Piper Aircraft Corporation

SERVICE LETTER

No. 641

Subject: Exhaust Stack Support Assembly Replacement

LEFT ENGINE SHOWN - RIGHT ENGINE OPPOSITE

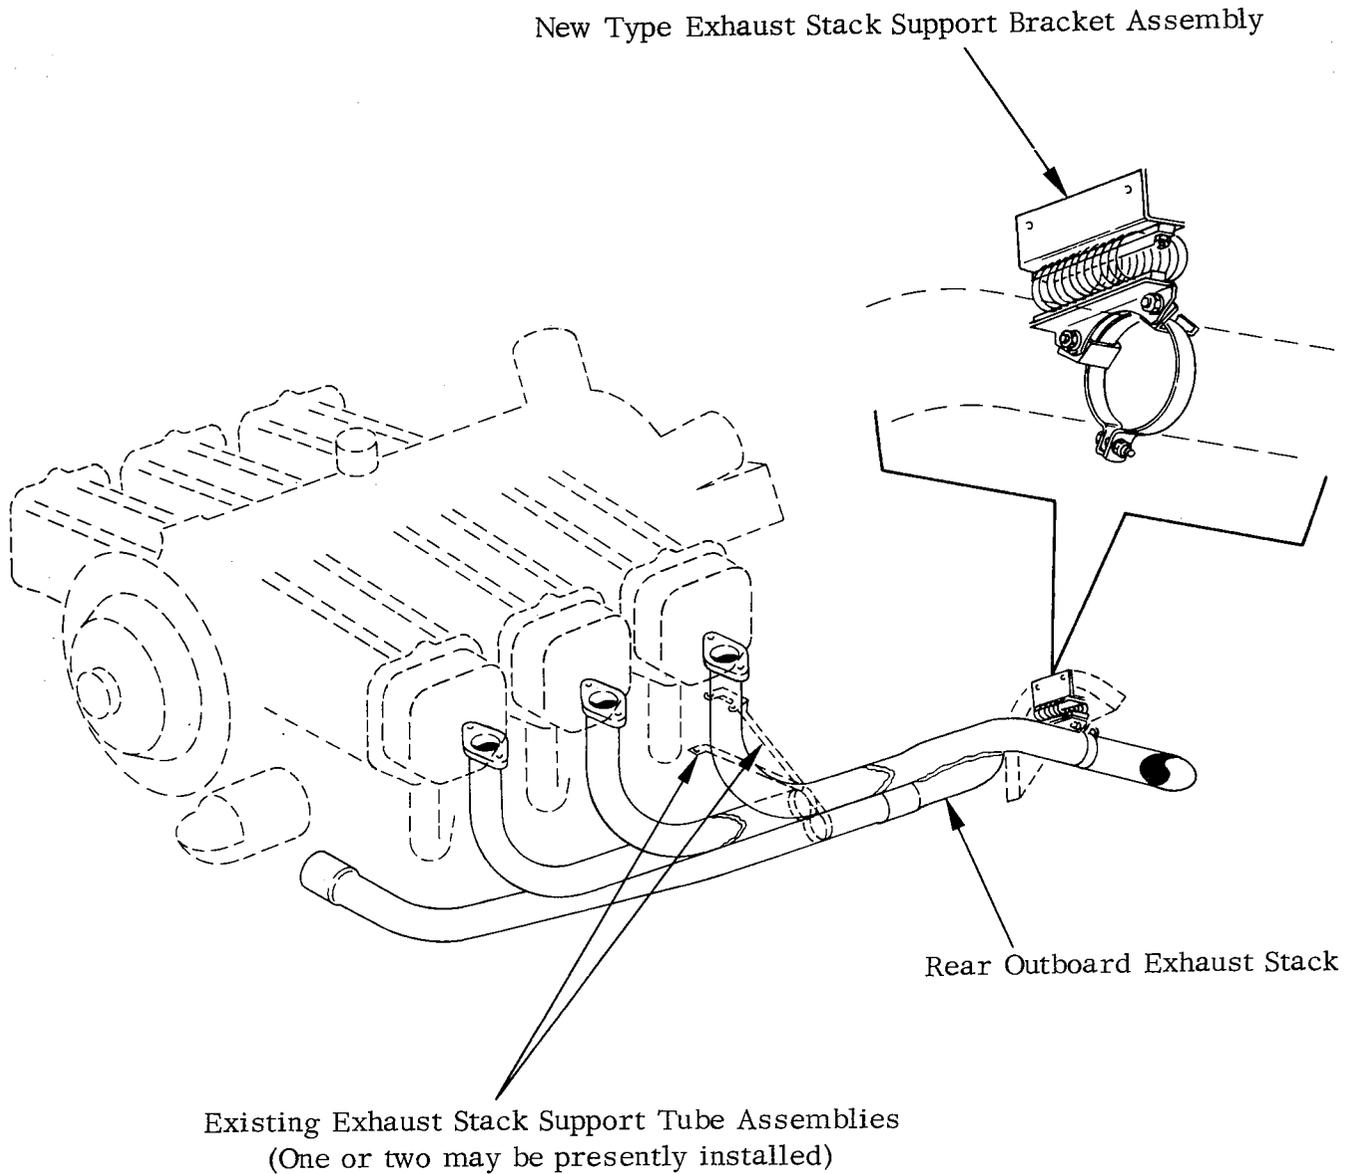
Purpose: To provide a field replacement kit containing material and instructions to replace the existing exhaust stack support tube assemblies on normally aspirated Aztecs with a new improved exhaust stack support bracket. These new support brackets have been designed to minimize the effects of possible stack vibration, thus improving the service life of the engine exhaust system. (Refer to sketch on reverse side of this letter for a pictorial description.)

Instructions: Contained in Exhaust Stack Support Assembly Replacement Kit, Piper Part No. 760 702.

Material Required: Two (2) each per aircraft (i.e., one each per engine) Exhaust Stack Support Assembly Replacement Kit, Piper Part No. 760 702 @ suggested unit list price \$32.35A.
